Responses to Action Items Introduced During the Mound Work Group Meeting of June 5, 2012

Mel Chew, Billy Smith, and Bryce Rich

The following discussion responds to the four action items raised during the June 5, 2012 working group meeting for the Mound SEC petition evaluation. The action items #1 (a-d) were developed during the discussion of NIOSH's paper, *Potential Stable Metal Tritide Exposures at the Mound Laboratory, Rev. 0* issued on March 14, 2012.

Figure 1. Swipes and average dose for the top 50% by period for Room R-108 (1983-1989)

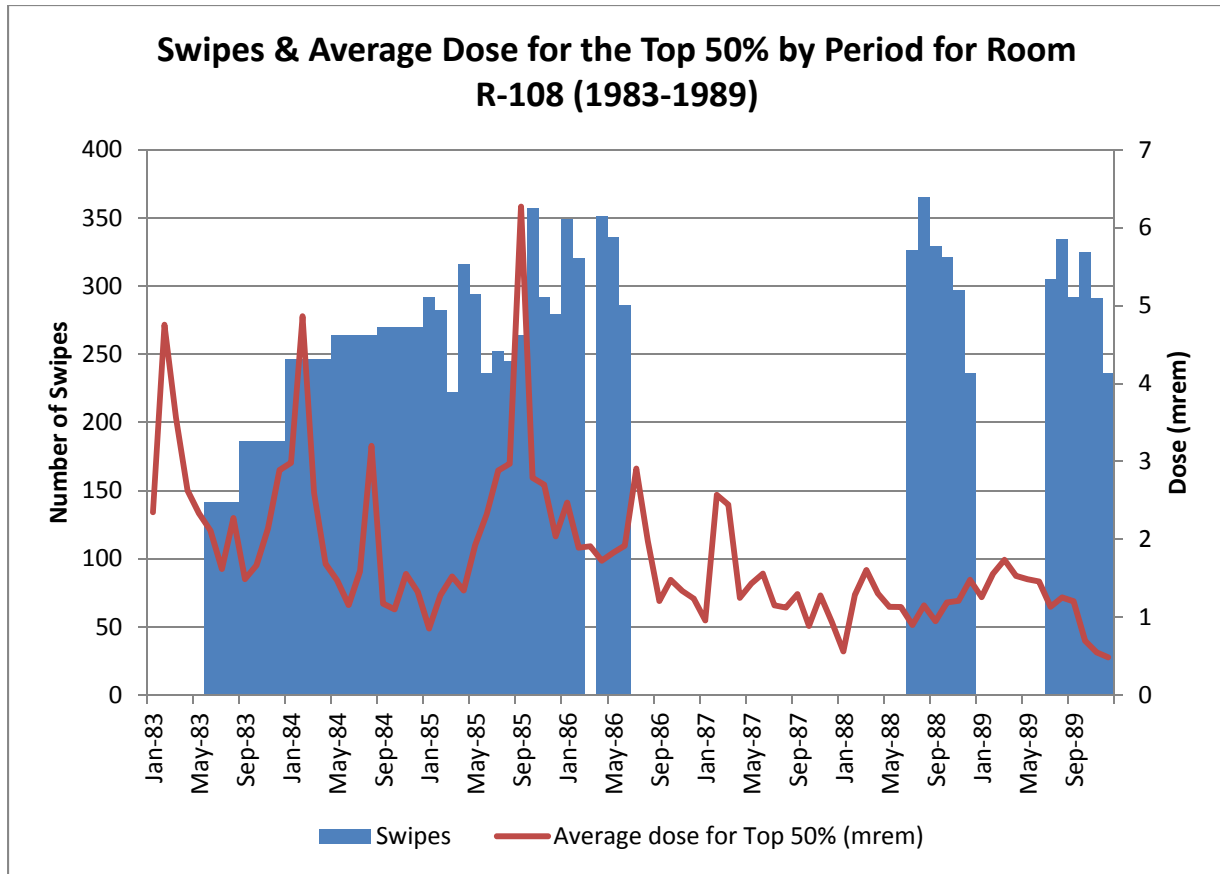
(1c) Address identified gaps in available swipes. What work (if any) was being performed during the gap periods?

The Section 4.1.1 (Ref. #10) and its revision (Ref. #11) dated July 6, 2012 provide three graphs of the NIOSH-developed swipe data, showing data "gaps." The following section of the report, Availability of Additional Data Sources (4.1.2), claims to point out data that was not considered

Most of the work actually occurred in SW-150 during the research period of working on the SMTs of interest. Figure 1 shows the relationship between the swipes and the average dose, by period, for Room 108 from 1983-1989. Figure 2 shows the relationship between the swipes and average dose, by period, for Room SW-8 for years 1980-1989. Both of these graphs indicate that the actual tritium doses, as determined through urine analyses, to workers, for years following the SEC period, were extremely low. These graphs also indicate that there were no unusual events or activities that contributed to increases in bioassay results during the gap periods. This supports the NIOSH position that the swipe results on either side of the gap periods can be used to extrapolate data in the gap periods.

The trends indicated from the graph of the average doses clearly indicates that the dose trends were not increasing as a result of unusual high activity during operations or scrap recovery that resulted in increased biological uptakes of tritium. These also corroborate that the swipe data from both sides of the gaps can be used to extrapolate the swipe data to within the gaps for R-108 and SW-8.
